Z-72
(2013)

CEARCREST ROAD TRACT
FOR
ZONING PLAN
LOCATED IN
LAND DISTRICT 2ND SECTION
COBB COUNTY, GEORGIA

PETITION NO: Z-72

ZONING COMMENTS:

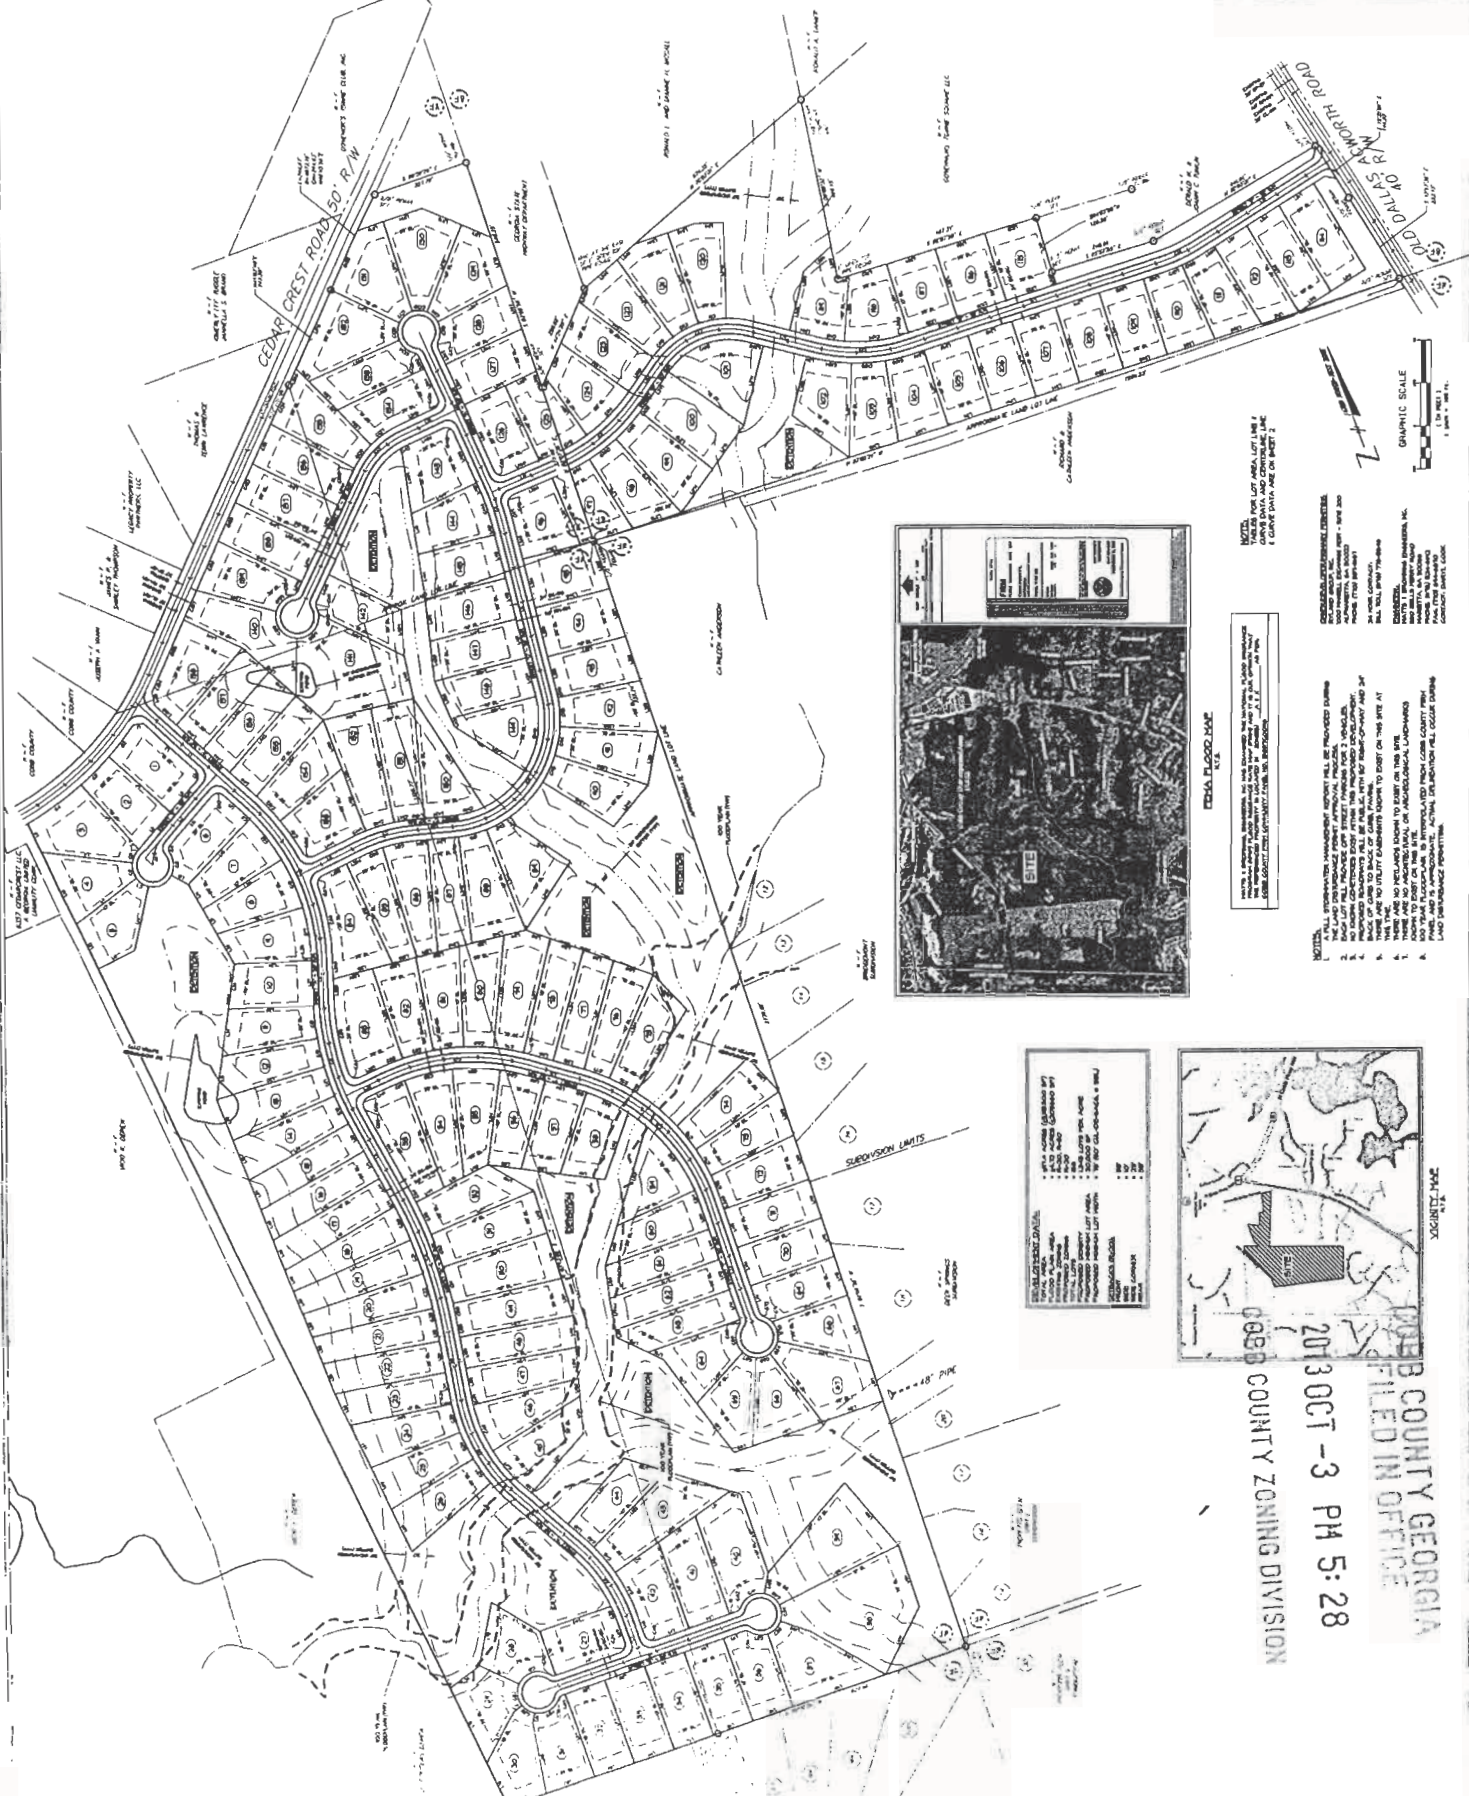
- Provide comprehensive hydrology/stormwater controls to include development of out parcels.
- Submit all proposed site improvements to Plan Review.
- Any **spring activity** uncovered must be addressed by a qualified geotechnical engineer (PE).
- Structural fill _____ must be placed under the direction of a qualified registered Georgia geotechnical engineer (PE).
- Existing facility.
- Project must comply with the Water Quality requirements of the CWA-NPDES-NPS Permit and County Water Quality Ordinance.
- Water Quality/Quantity contributions of the existing lake/pond on site must be continued as baseline conditions into proposed project.
- Calculate and provide % impervious of project site.
- Revisit design; reduce pavement area to reduce runoff and pollution.

- No Stormwater controls shown _____
- Copy of survey is not current – Additional comments may be forthcoming when current site conditions are exposed.
- No site improvements showing on exhibit.

Recommend coordinating with Cobb County DOT on the Cedarcrest Road widening project. A median is shown at the location of the ingress/ egress.

- Site plan received by the Zoning Division on October 3, 2013, with the District Commissioner approving minor modifications;
- Architecture to be approved by the District Commissioner;
- Water and Sewer Division comments and recommendations;
- Stormwater Management Division comments and recommendations;
- Department of Transportation comments and recommendations; and
- Owner/developer to enter into a Development Agreement pursuant to O.C.G.A. §36-71-13 for dedication of system improvements to mitigate traffic concerns.
